## Production Discontinuation of the MELSEC-F FX3GE Series Models

April 2024 (Ver. B: October 2024)

FAM-A-0090-B

### FX5S + FX5-4A-ADP

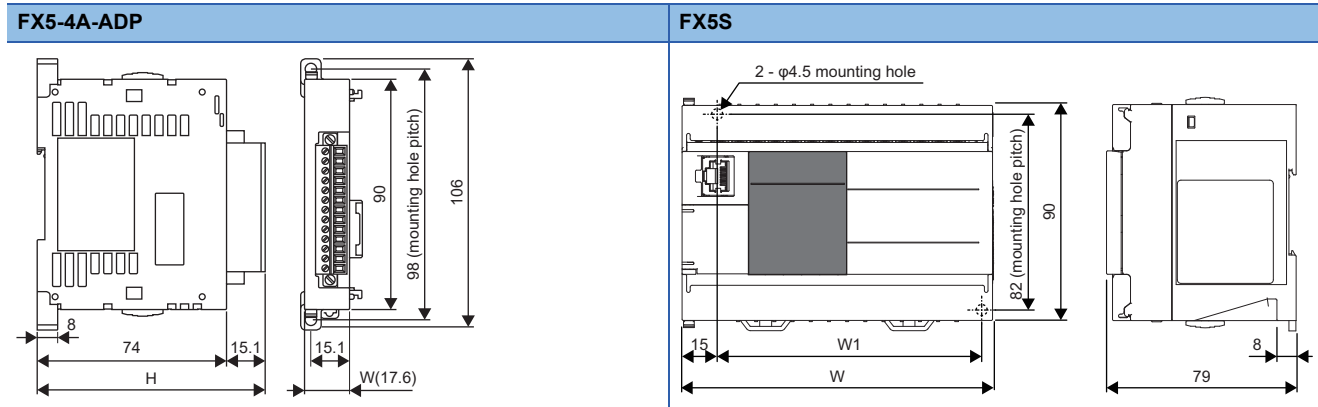
Model	W	W1	H
FX5S-30M□ + FX5-4A-ADP	100mm + 17.6mm = 117.6mm (-12.4)	81mm (-24)	74mm + 15.1mm = 89.1mm (+3.1)
FX5S-40M□ + FX5-4A-ADP	130mm + 17.6mm = 147.6mm (-27.4)	111mm (-39)	74mm + 15.1mm = 89.1mm (+3.1)

Dimensional differences from the FX3GE are shown in parentheses ( ).

**FX5UJ + FX5-4A-ADP**

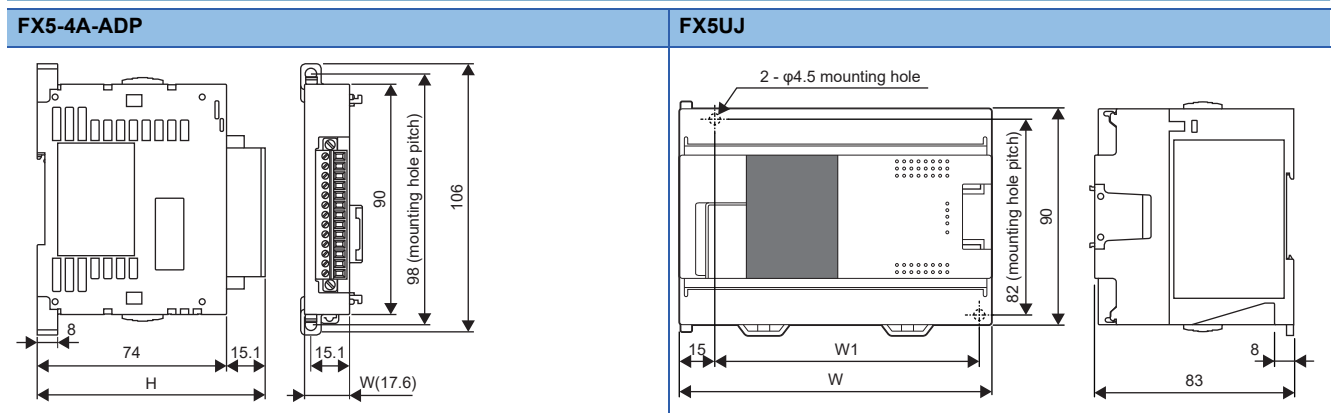
Model	W	W1	H
FX5UJ-24M□ + FX5-4A-ADP	95mm + 17.6mm = 112.6mm (-17.4)	76mm (-29)	74mm + 15.1mm = 89.1mm (+3.1)
FX5UJ-40M□ + FX5-4A-ADP	130mm + 17.6mm = 147.6mm (-27.4)	111mm (-39)	74mm + 15.1mm = 89.1mm (+3.1)

Dimensional differences from the FX3GE are shown in parentheses ( ).
